Planning Commission

Planning Commission Meeting Agenda
Hartland Township Hall
Thursday, September 23, 2021
7:00 PM

Hartland Township Planning Commission Meeting Agenda Memorandum

Subject: Site Plan #21-012 Hartland Crossing Planned Development (PD) Concept Plan

CONCEPTUAL OUTLOT & MULTI-FAMILY PLAN

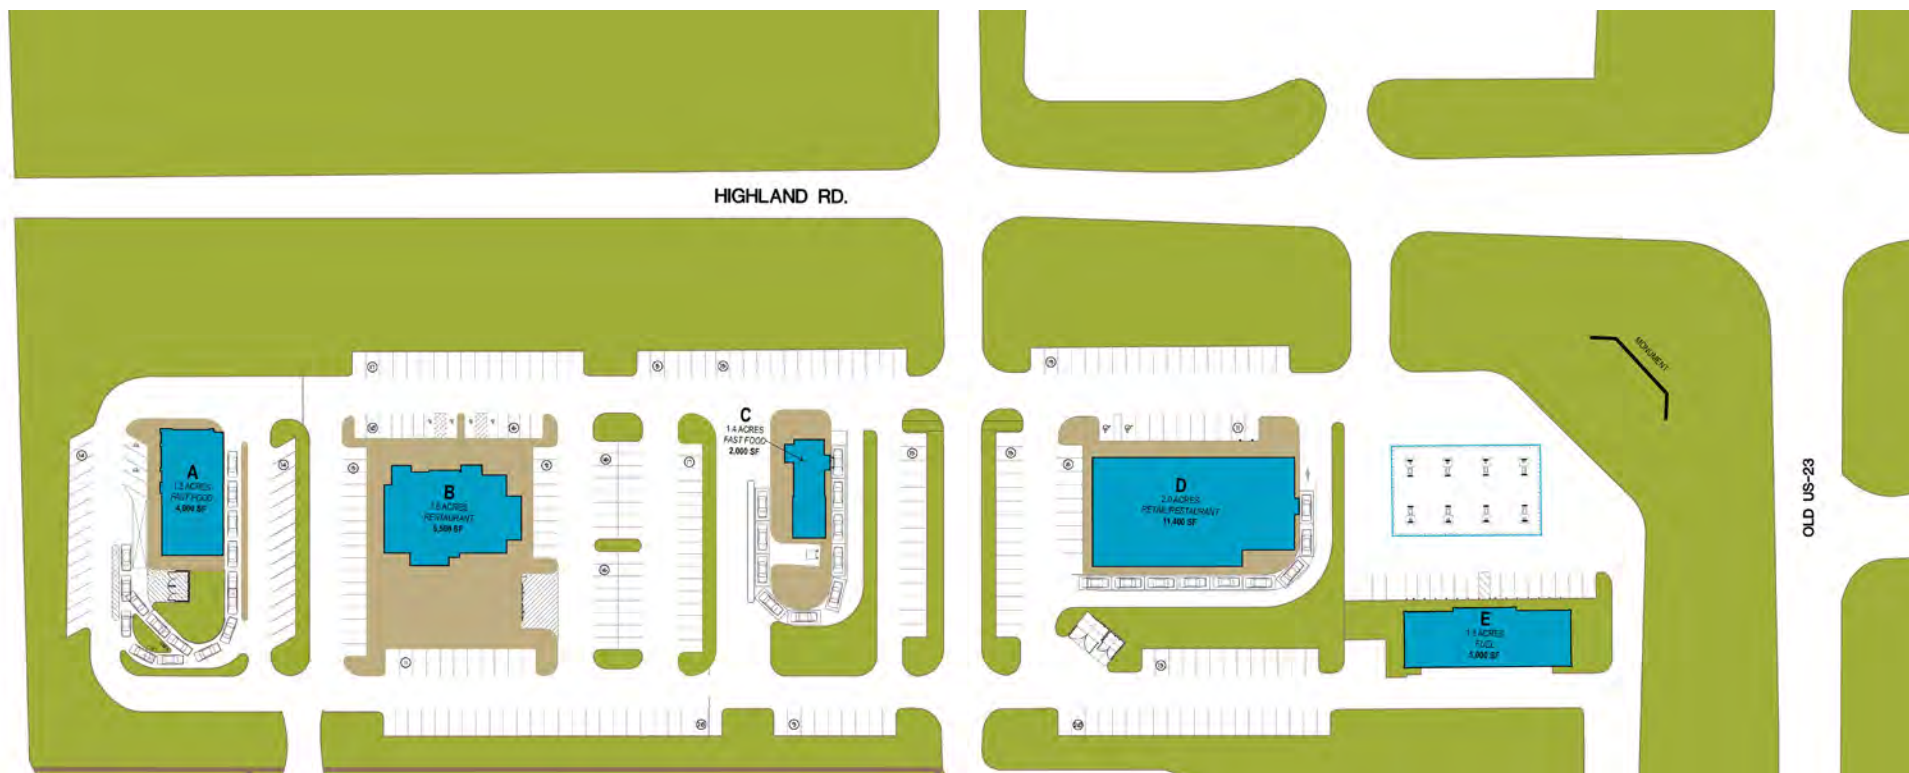
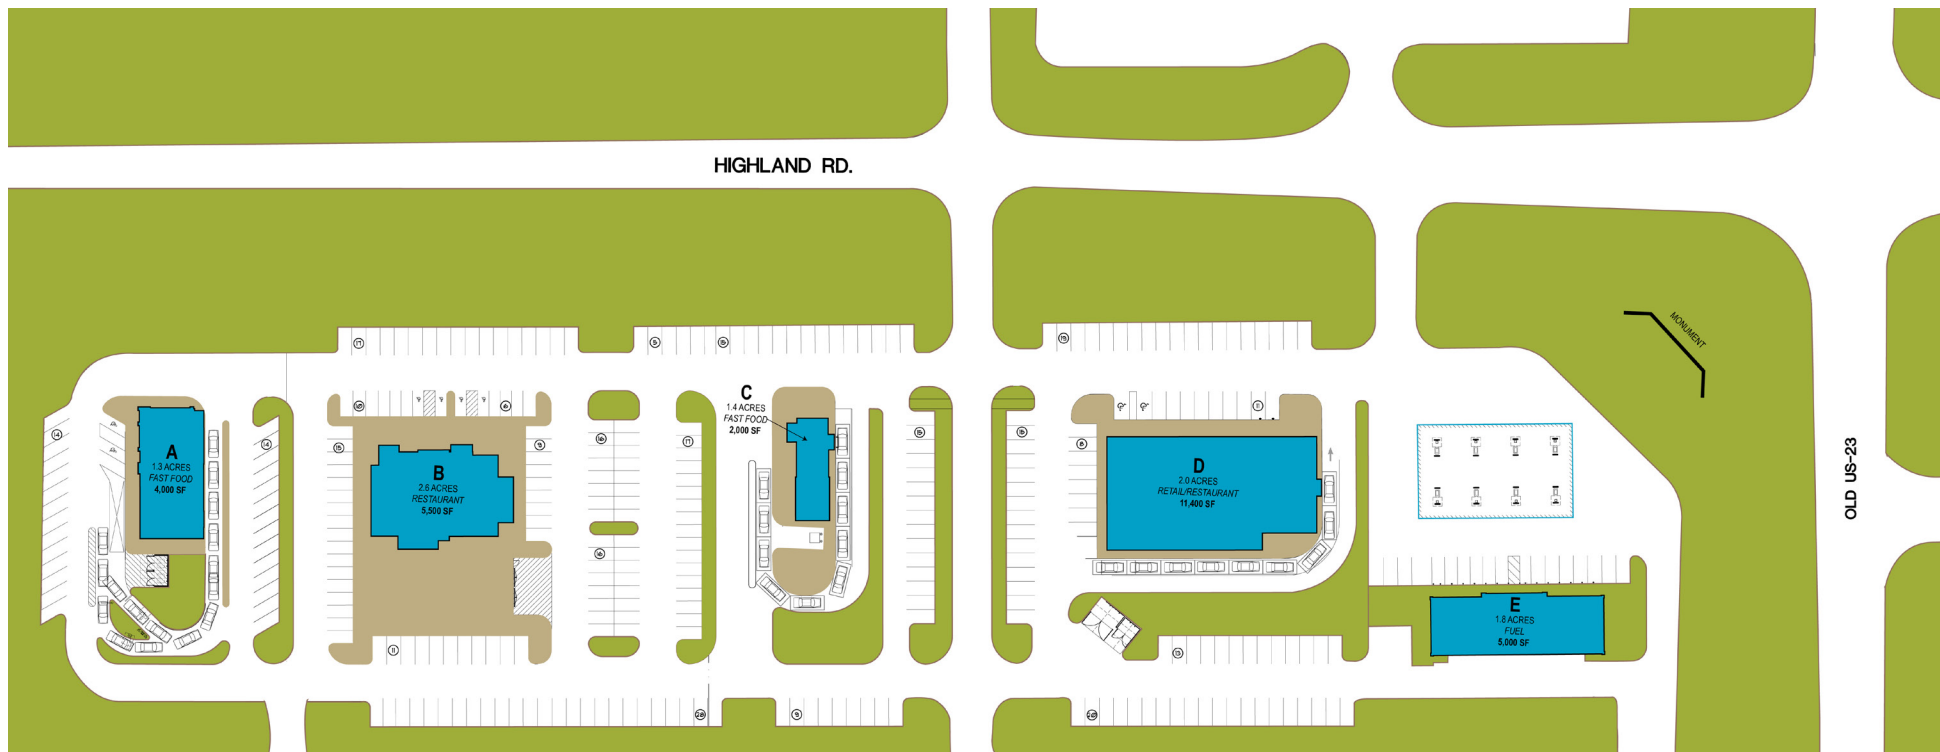
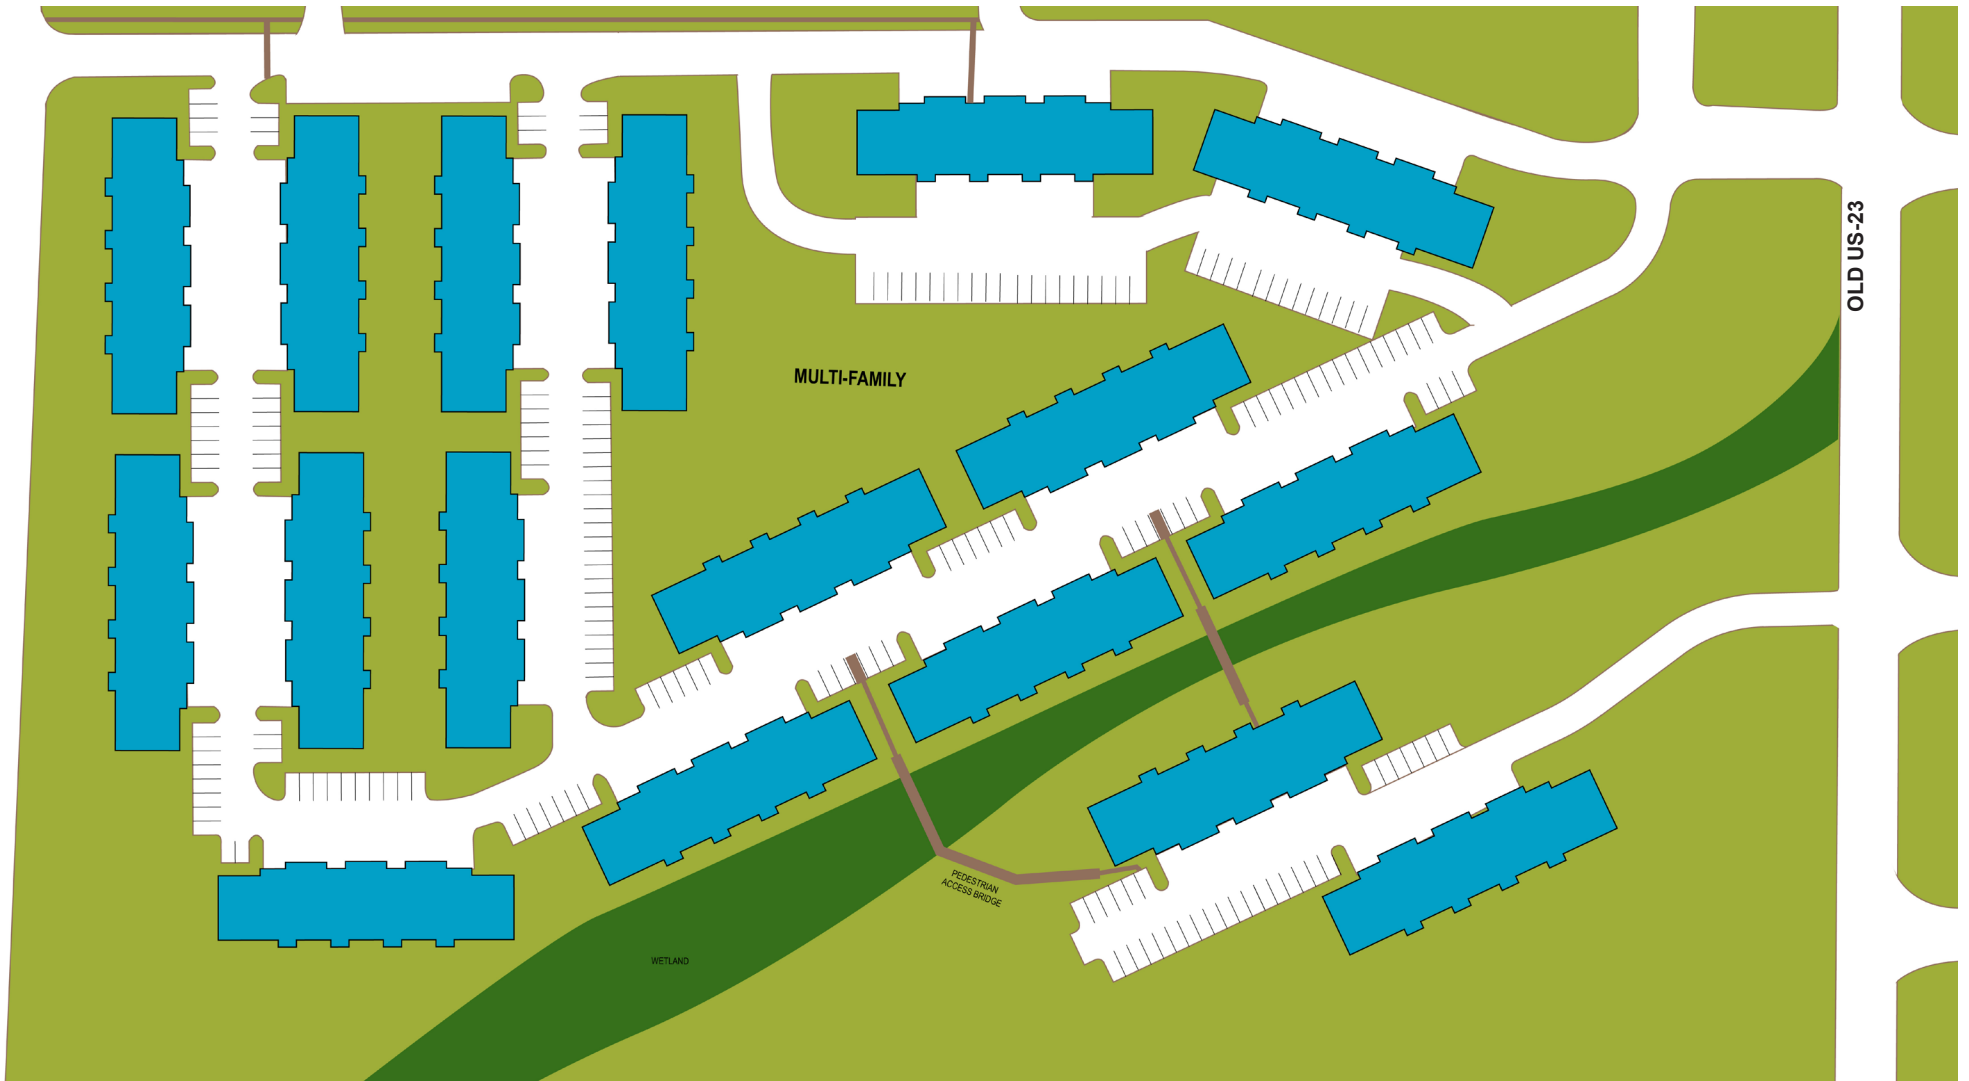
The site plan was not drawn to scale. The commercial uses are grouped along the northern portion of the site, with access provided from the Highland Road entrance. The entrance drive from Highland Road travels south and connects to the east-west internal road. Once one enters the site, internal drives provide circulation to each business and associated parking, as well as access to the residential portion of the site to the south.

The plan shows five (5) conceptual outlots which are meant to be place holders for future businesses. The plan does not state the overall size of the commercial area or for any outlot. The plan is not intended to be the final site plan for the commercial portion of the site. The following businesses/uses are shown, as possible options: two (2) fast food restaurants each with drive-through service; one (1) dine-in restaurant;

Using the applicant's density of fifteen (15) dwelling units per acre and using the entire land area of 29.85 acres, the number of units equates to 448 dwelling units. This exceeds the number of dwelling units allowed even if a 40% density bonus should be awarded. The proposed plan may not be representative of accommodating that number of units (448 dwelling units). The applicant noted to the Planning Commission on August 12, 2021, that there would be approximately 300 units in total.

The applicant is proposing a density of fifteen (15) dwelling units per acre, which could equate to a total of 448 units, if using the entire land area of 29.85 acres. The Township's Comprehensive Plan could not support this density nor could Section 3.1.18.C.iv. of the Zoning Ordinance (PD Planned Development - Residential Density), as currently written. Consideration could be given to amending the Township's Comprehensive Plan and FLUM to allow for a higher density for this subject site and/or the area currently designated as SPA on the 2021 FLUM at the southwest corner of Highland Road and Old US-23.

Lastly the applicant could consider modifying the development plan to comply with the current density regulations or possibly acquire additional land south of the PD site and thus increase the land area which could modify the proposed residential density.

CONCEPTUAL RENDERINGS

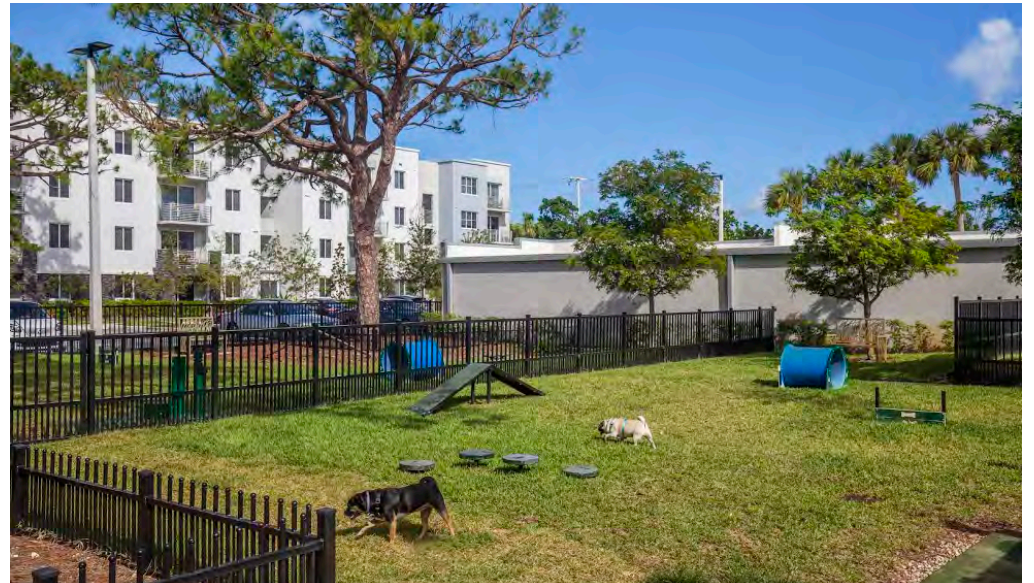
Conceptual building elevations of the residential buildings are provided as well as a conceptual depiction of a common recreation area, presumably for the residents in the PD. The architectural renderings show two-story residential buildings comprised with a mix of building materials (siding and stone products). The number of apartment/residential units is not stated. Building elevations were not provided for the commercial buildings.
